TOWN OF GLASTONBURY
GL-2019-19
State DAS Project No. 054-0098CV
GLASTONBURY HIGH SCHOOL KITCHEN CODE VIOLATION PROJECT
ADDENDUM NO. 2
February 28, 2020

This Addendum dated February 28, 2020 forms a part of the Contract Documents and modifies the original Bidding Documents dated February 13, 2020.

END OF ADDENDUM NO. 2

1A 1 HR. RATED CMU WALL
3" = 1'-0" U.L. DESIGN NO. U905

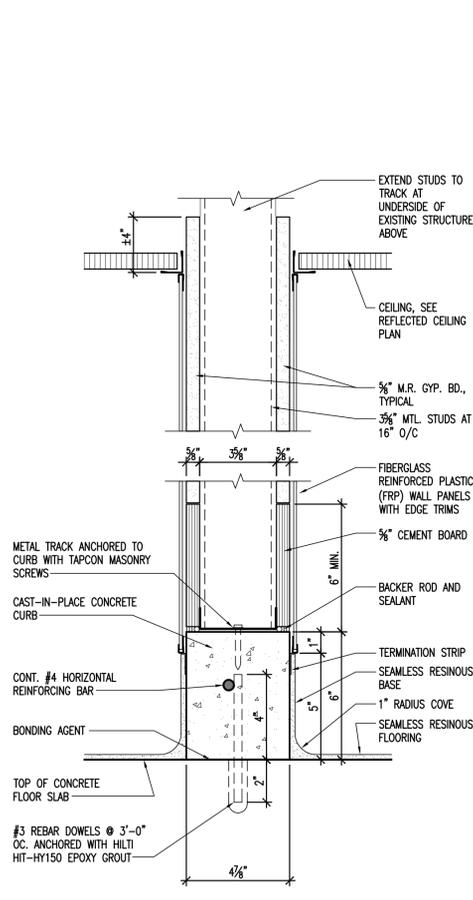
Question 9: *Drawing A101 – please clarify the intended partition type for these infills:*
a. Lockers 3 – south wall
b. WC 5 – west wall

b. Provide 1 hour fire rated masonry wall infill at the west wall of WC 5. Refer to partition type 1A, revised sheet G-002.

Item #1	<u>Drawing G-000 and G-001</u>	ADDED drawings AD-102 and HA-002 to drawing list
Item #2	<u>Drawing G-002</u>	ADDED sealant at top of Partition Type 1, CMU wall. ADDED partition type 1A – 1 HR. Rated CMU Wall.

HA-001

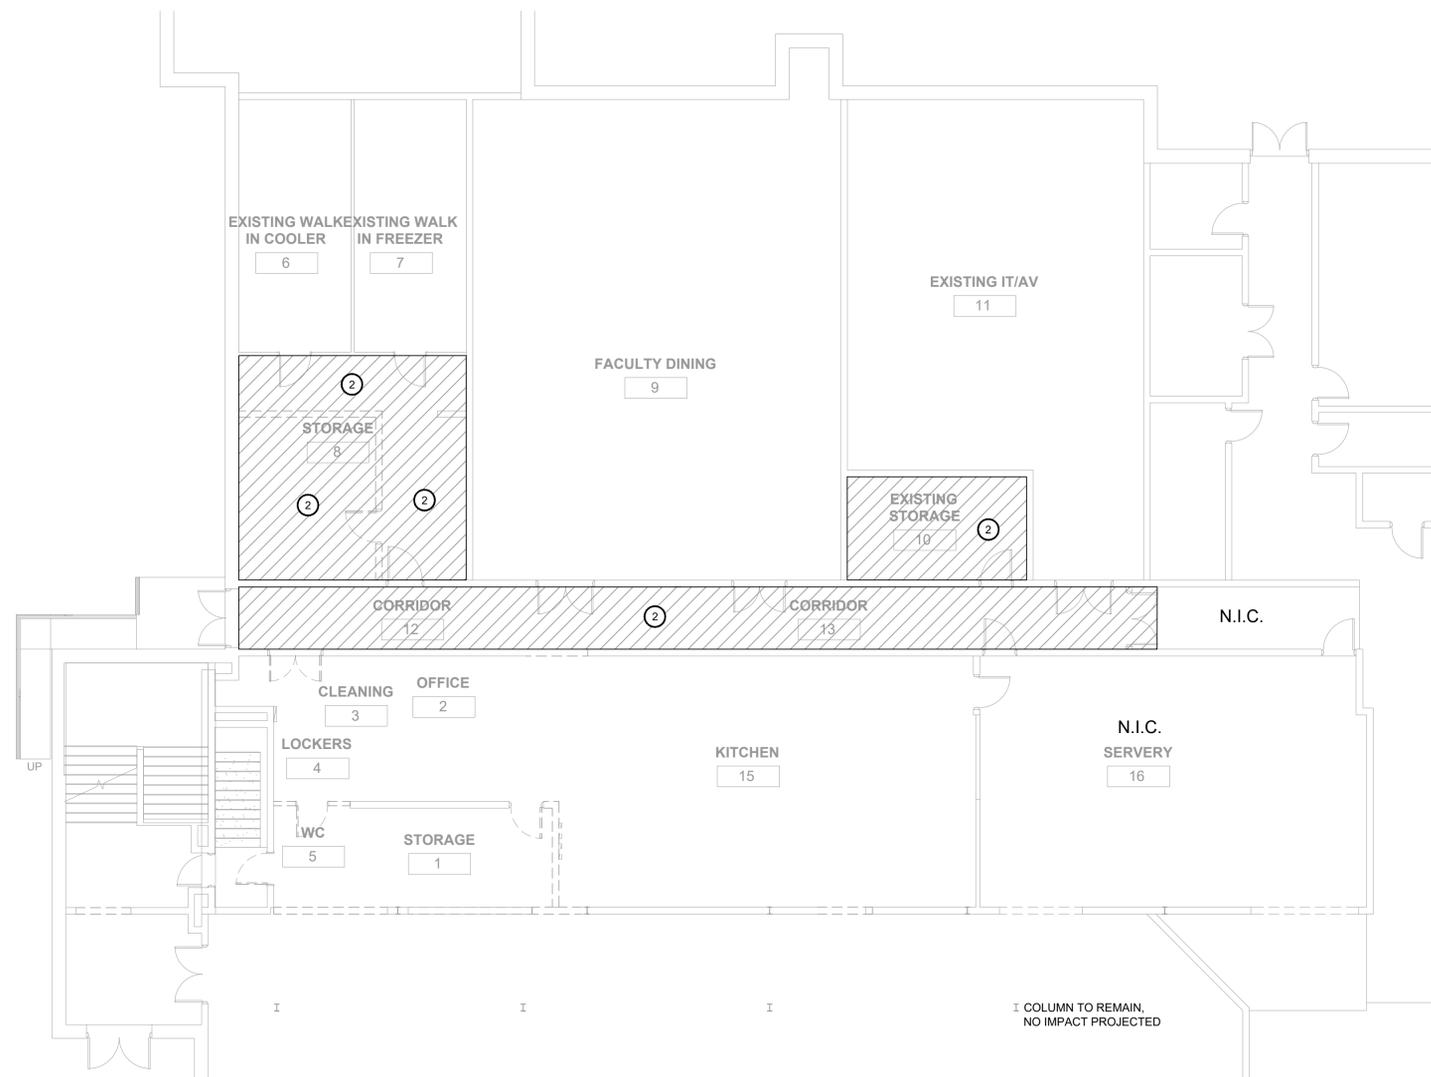
Answer: Refer to enclosed revised specification section 011000. Phase 1 is abatement work, as indicated on Drawing HA-001, that was completed during the summer of 2019. Drawing HA-001 is provided for information only. Phase 2 is the contract for General Construction and comprises all work contained in the drawings and specifications, with

Item #3	<u>Drawing HA-001</u>	REVISED scope to clarify abatement that was completed during Phase 1.
Item #4	<u>Drawing HA-002</u>	ADDED sheet HA-002 to clarify abatement scope to be completed during Phase 2.

FIRST FLOOR ABATEMENT PLAN PHASE 2

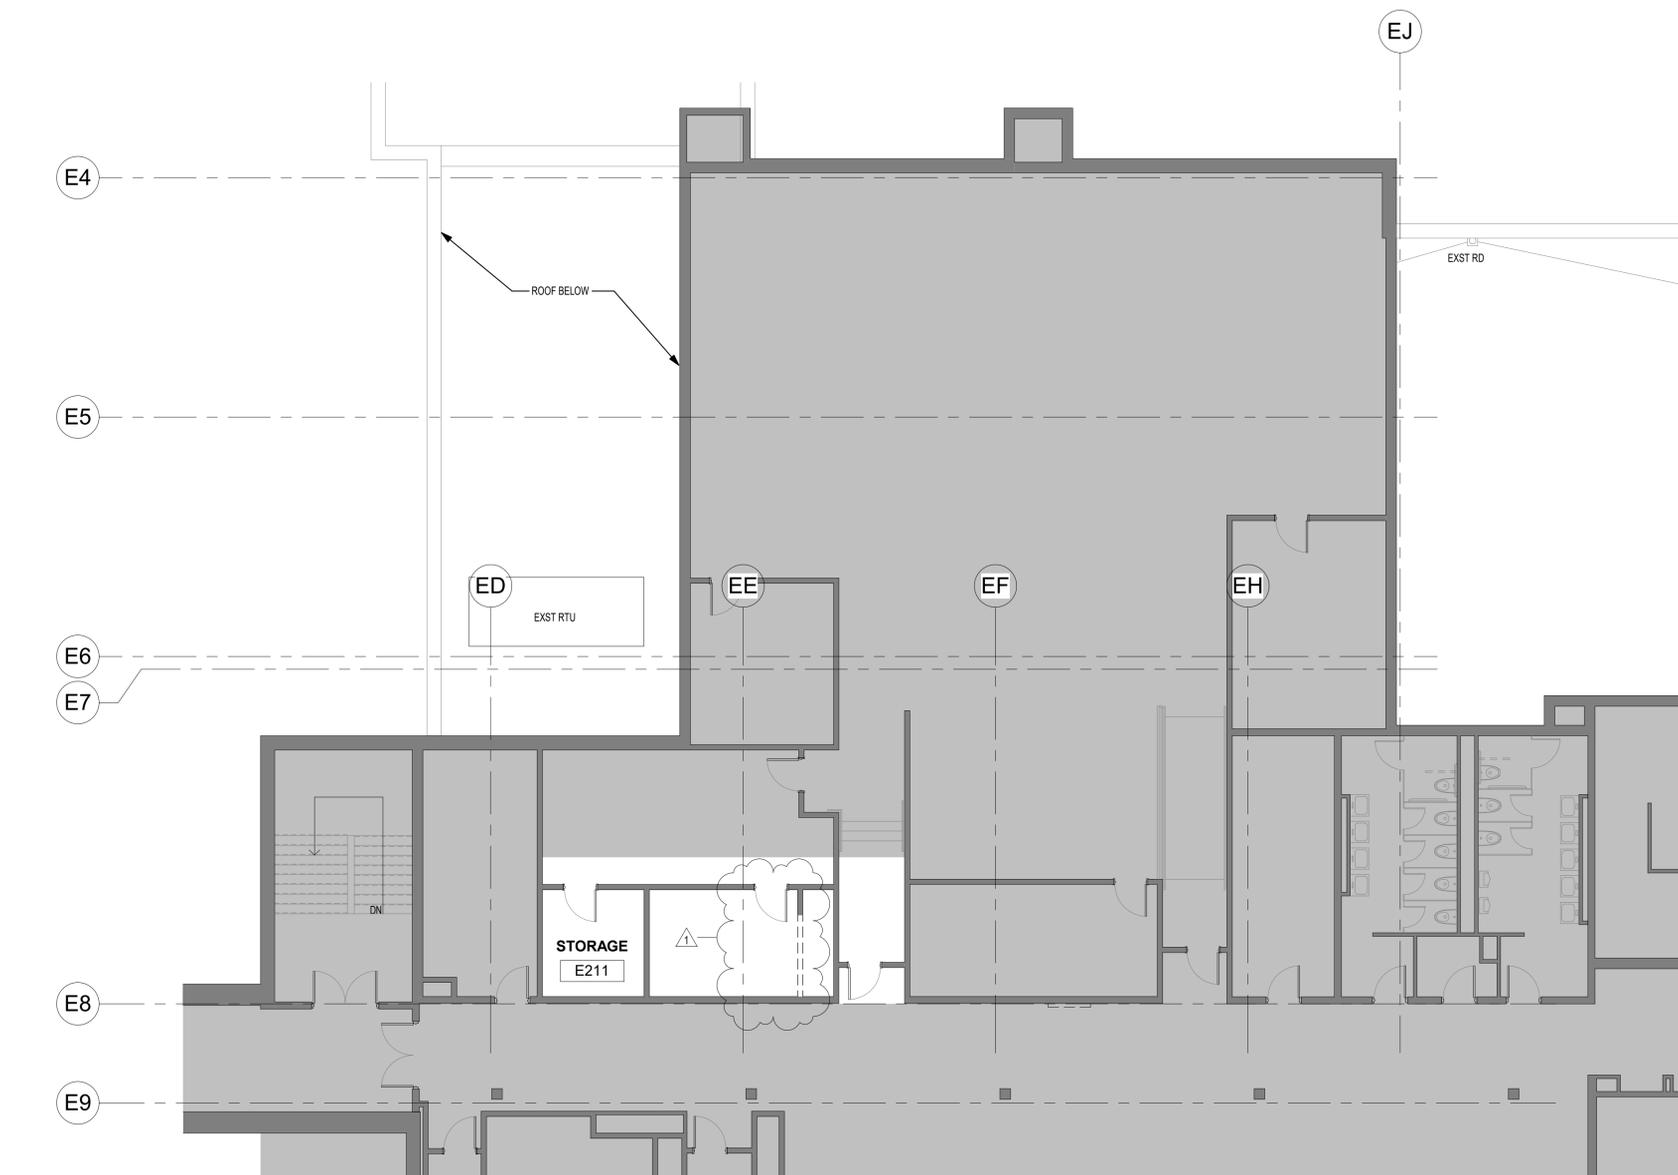
the exception of the abatement work. Phase 2 work includes coordination of remaining abatement work, performed under a separate contract and as indicated on HA-002. Spec 011000 Para 1.4. B, Construction Schedule submittal regarding phases, is not required and is removed from the specification.

AD-102

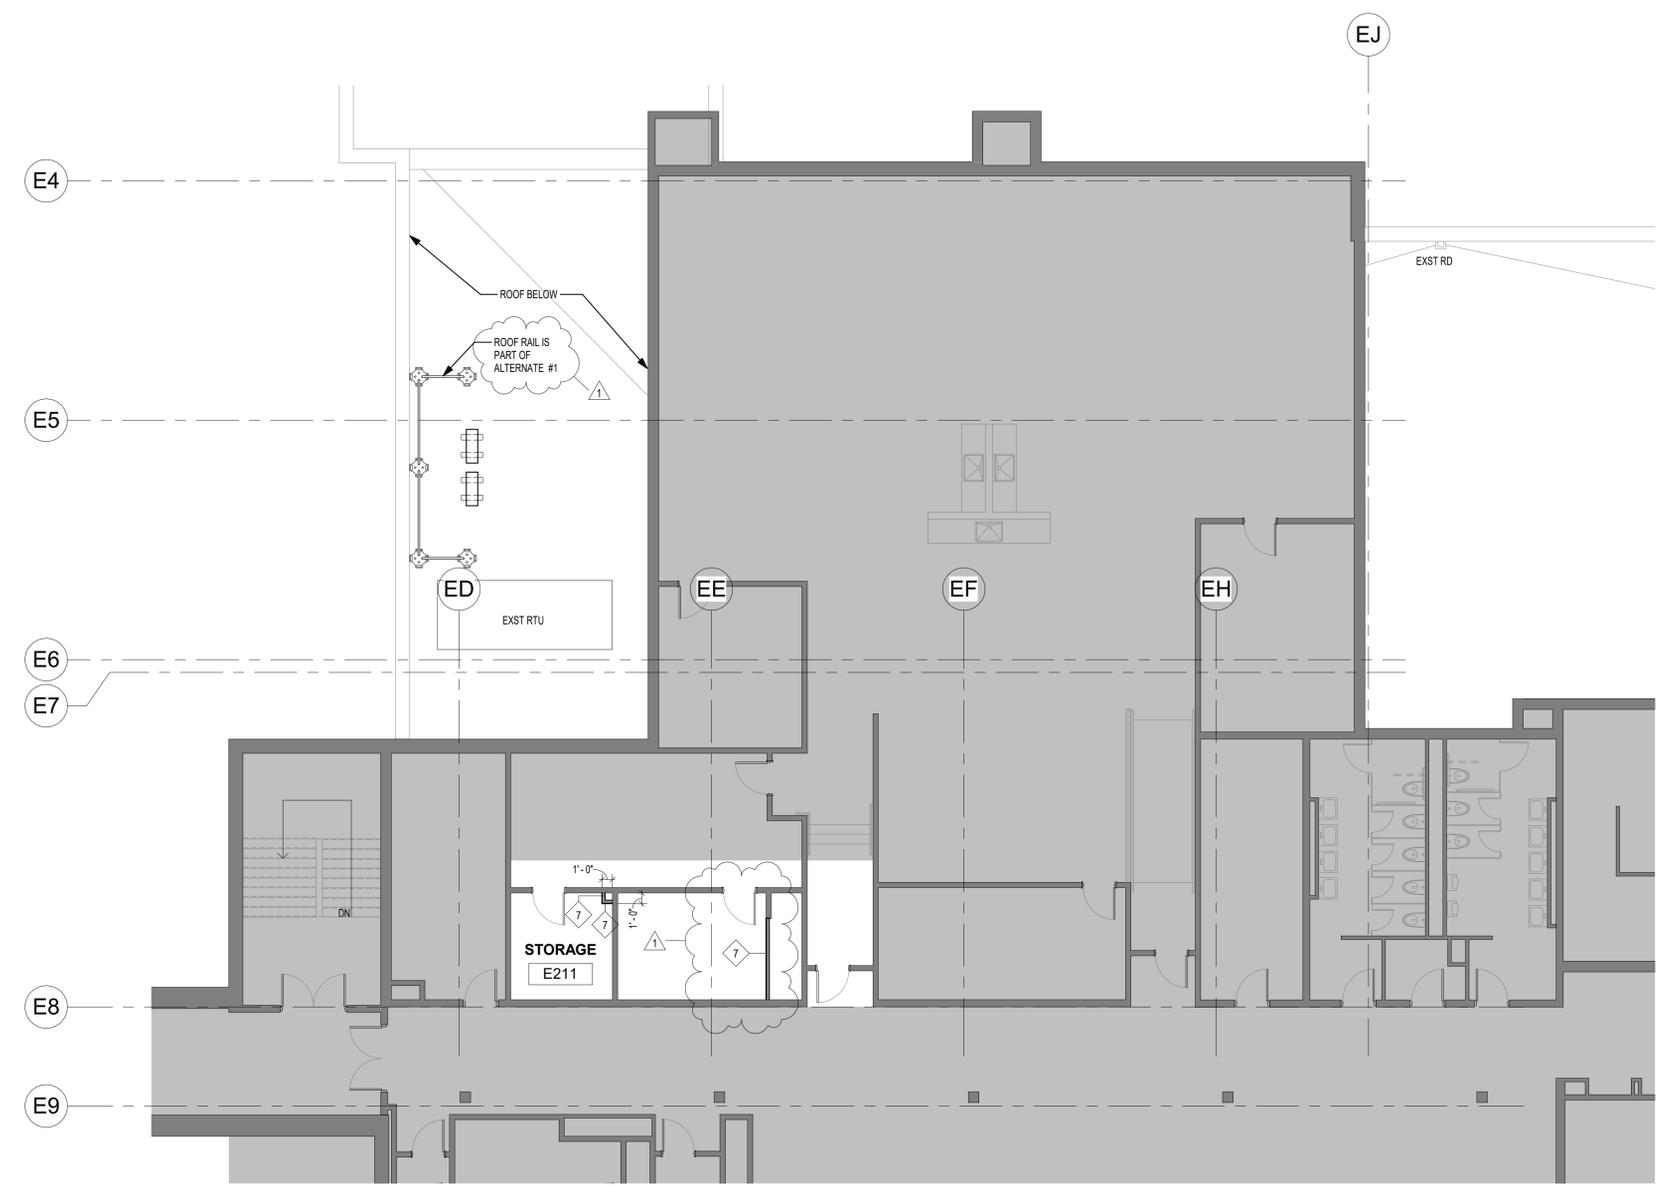
Item #5	<u>Drawing C-101</u>	REVISED location of sanitary line exiting building to match plumbing drawings.
Item #6	<u>Drawing AD-102</u>	ADDED sheet AD-102, “Second Floor Demolition Plan” showing demolition of shaft wall at Storage Room E211

A-102

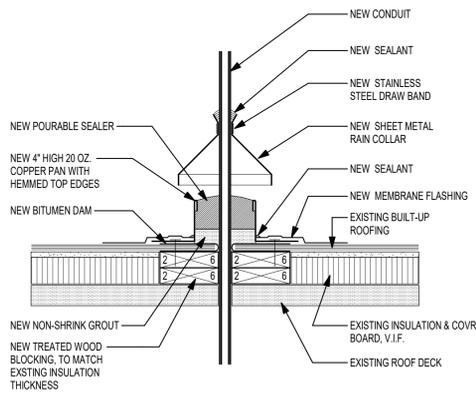
Item #7	<u>Drawing A-101</u>	DELETED counter line in Office 2.
Item #8	<u>Drawing A-102</u>	ADDED new shaft wall at Storage Room E211 ADDED note clarifying steel roof rails as part of Alternate #1.

A-103

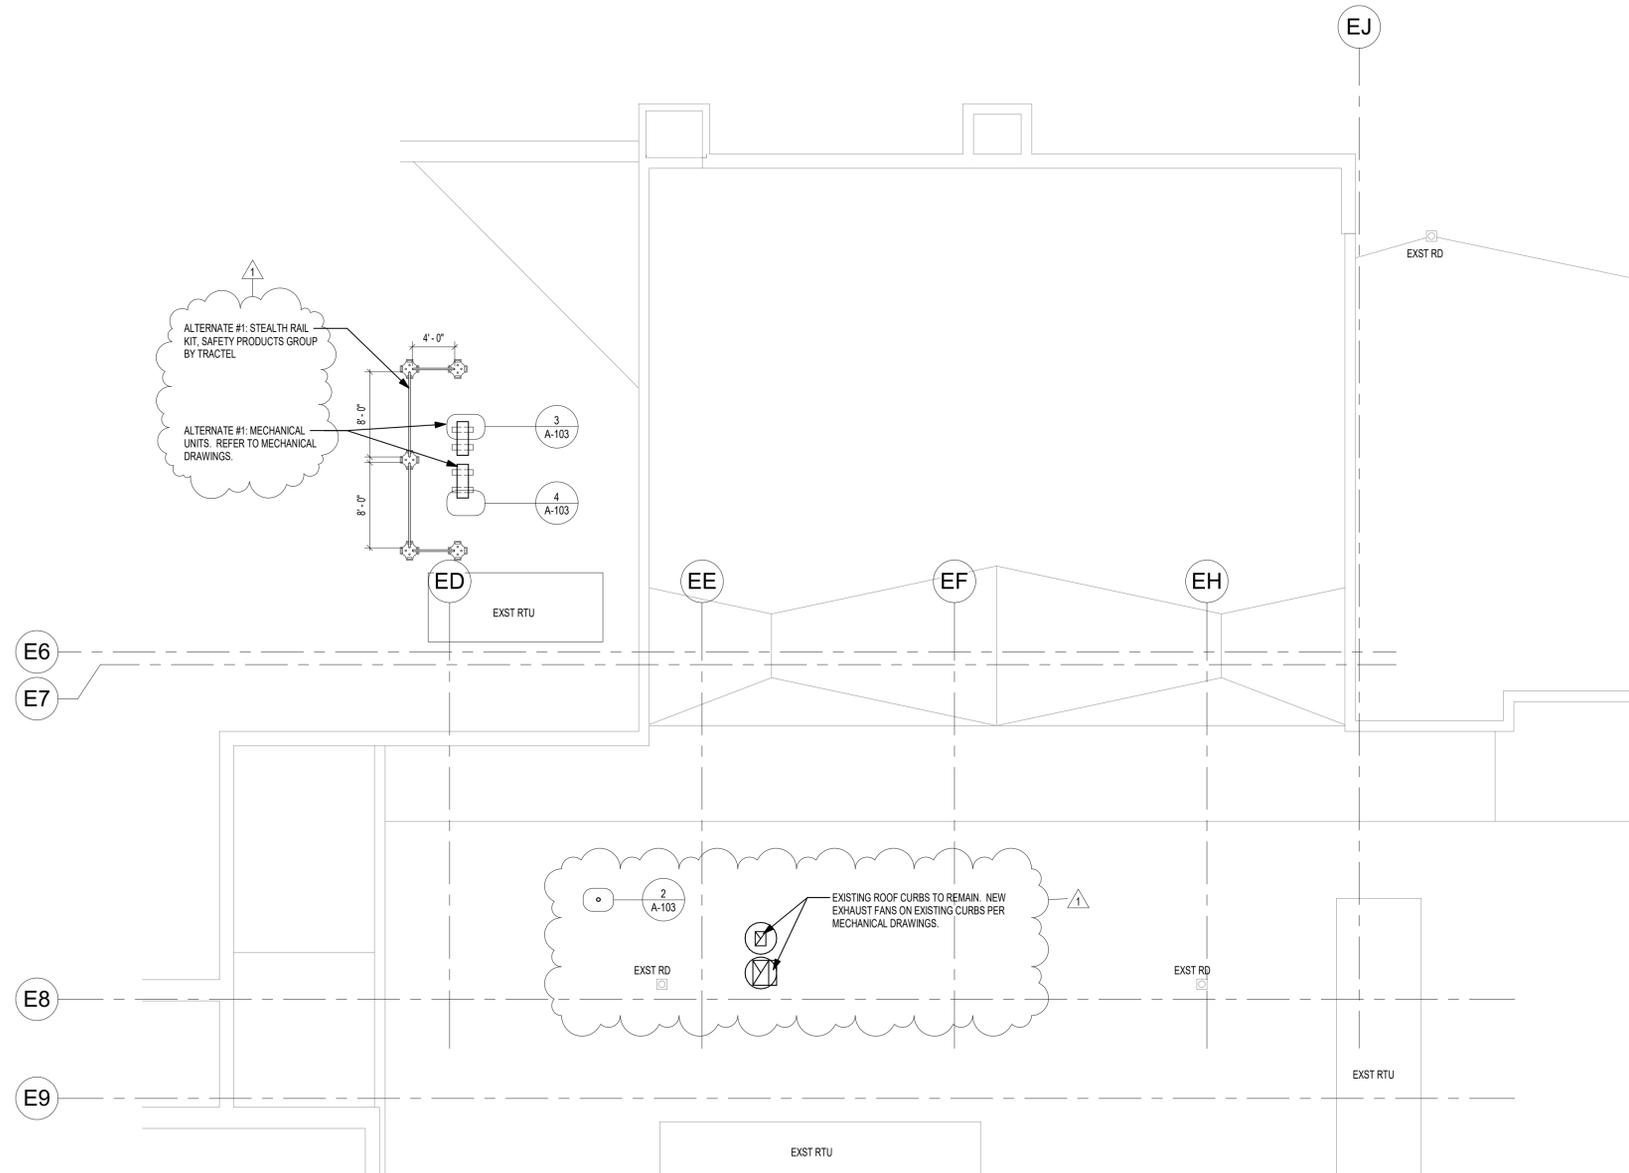
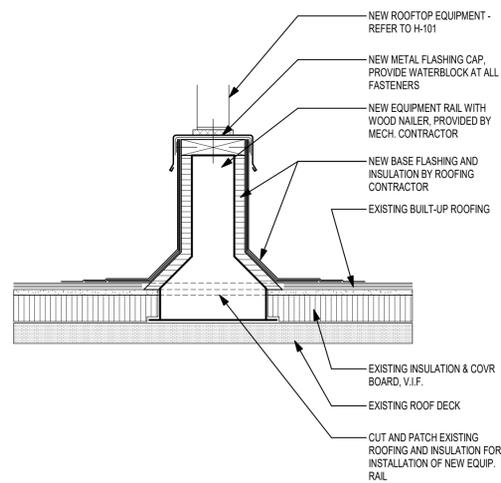
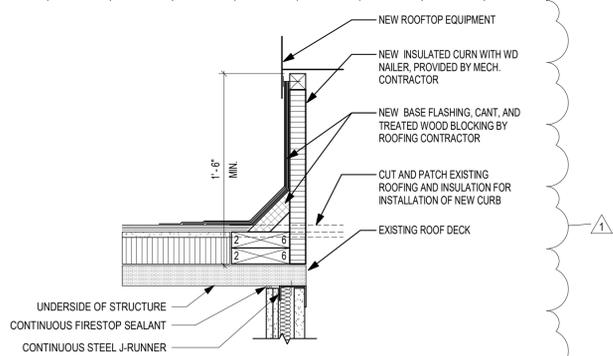
Question 10: *Spec 055200 – please confirm these roof safety rails are BASE BID work, and are NOT included in ALTERNATE #1.*

Answer: The safety rails should be included as part of Alternate #1. See attached revised Specification Section 012300 and revised sheet A-103.

Item #9	<u>Drawing A-103</u>	REVISED Detail callout 2/A-103 at kitchen exhaust fan roof penetrations to be detail callout 2/A-103 for dryer vent at roof. ADDED Note “Existing roof curbs to remain. New exhaust fans on existing curbs per mechanical drawings.” REVISED Detail 2 “Roof Detail – New Curb” to show the connection of the rated shaft in room E211 to the roof deck. ADDED note clarifying roof rail and mechanical units are part of Alternate #1.
